## IDAP REPORT

<b>Property:</b>	105 Mintaro Avenue STRATHFIELD Lot: 18 DP: 35995 DA 2022/38
<b>Proposal:</b>	Demolition of existing structures, tree removal and construction of two-storey dwelling with basement parking, in-ground swimming pool and associated landscaping.
<b>Applicant:</b>	A Wu
<b>Owner:</b>	NSW Foresight Enterprise Pty Ltd
<b>Date of lodgement:</b>	22 February 2022
<b>Notification period:</b>	3 March 2022 – 18 March 2022
<b>Submissions received:</b>	Nil
<b>Assessment officer:</b>	J W Brown
<b>Estimated cost of works:</b>	\$1,345,300.00
<b>Zoning:</b>	R2-Low Density Residential - SLEP 2012
<b>Heritage:</b>	No
<b>Flood affected:</b>	No
<b>Is a Clause 4.6 Variation Proposed:</b>	N/A
<b>RECOMMENDATION OF OFFICER:</b>	Approval

Figure 3: Basement Plan

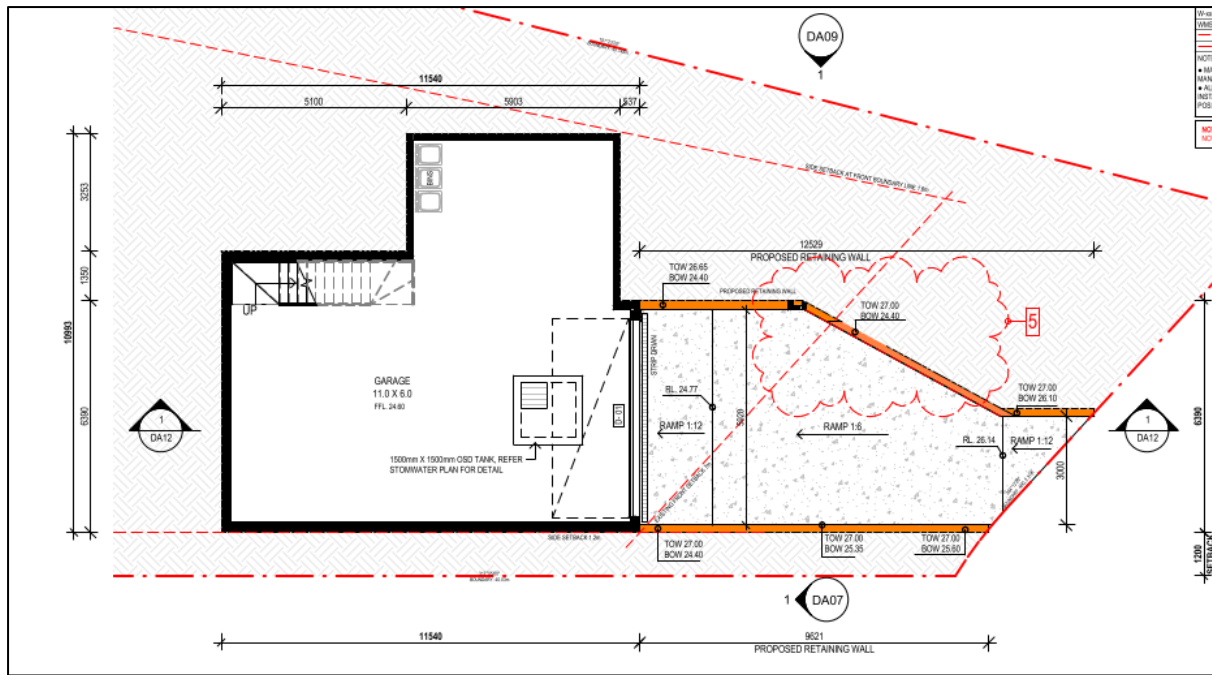
The application was referred to Council's Traffic Manager who required a swept turning path analysis using B85 car. As the original basement was unlikely to allow vehicles to enter and exit in a forward direction. The applicant provided a redesign of the basement to allow for forward entry and exit. The applicant provided architectural templates that were inaccurate and therefore it was requested again that the applicant provide proper auto turn templates to show both vehicles being able to enter and exit in a forward direction. The applicant has now provided the correct documentation and it has been reviewed by Council's Traffic Manager who was satisfied that both vehicles would be able to enter and exit in a forward direction. No further objection to the proposal was given subject to the conditions of consent.

The proposed development satisfies the relevant objectives and most of the controls of the SCDP 2005 in that it provides the minimum number of required parking spaces and adequate vehicular access provisions. The basement has been kept to less than 1m above natural ground level, does not extend beyond the ground floor above, has been designed so that vehicles can enter and exit in a forward direction and maintains a minimum internal height of 2.2m.

Although the ramp for the basement extends beyond the 3.5m SCDGP 2005 requirement to 5.92m at its greatest point. This increase in driveway width helps to provide better access to the basement for the vehicles. It has also been reduced in size from the original submitted plans balancing hardstand space and landscaping within the front setback. It is an acceptable variation for this irregular shaped lot.

Figure 4: Ground Floor Plan

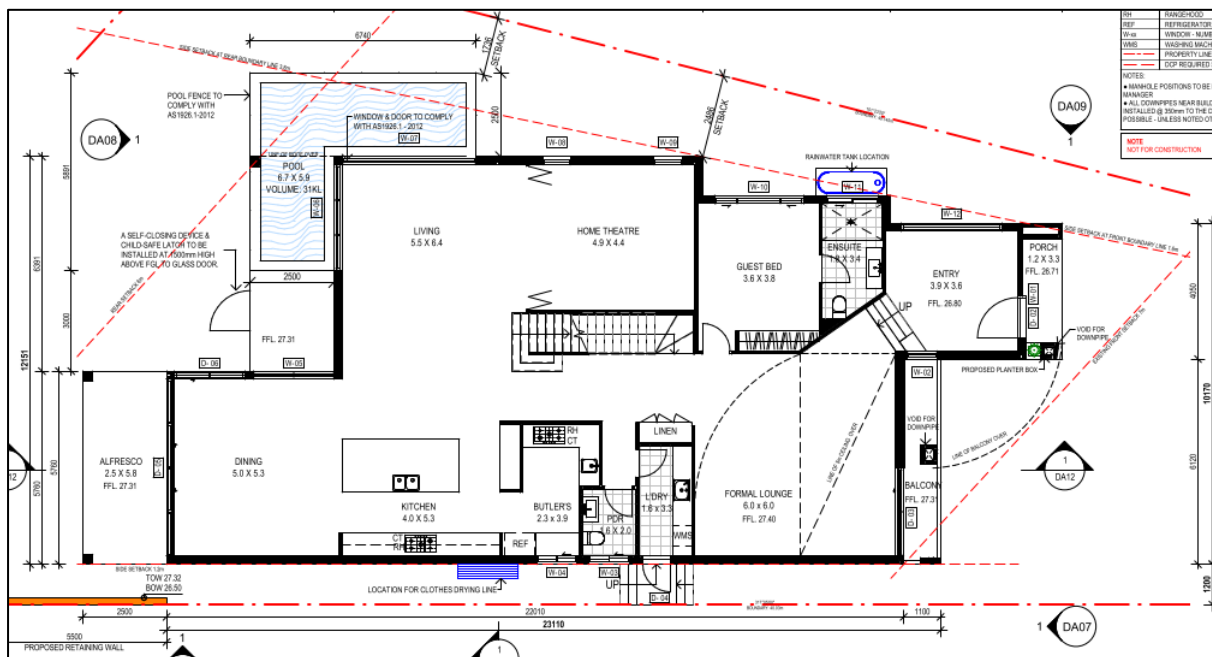
A non-compliance of the floor to ceiling height is caused by the void above the formal lounge at the front of the dwelling. The requirement under the SCDCP 2005 is 3m, which is achieved throughout the whole dwelling except for the void area. Additional information was requested by the applicant to reduce the void's size. The final set of plans that were provided reduced the roof height, which in turn reduced the floor to ceiling height from 6m to 5m therefore reducing the scale of the void. The reduction in height of the roof has improved the overall bulk of the void and reduced overshadowing. Therefore, the non-compliance is acceptable in this circumstance.
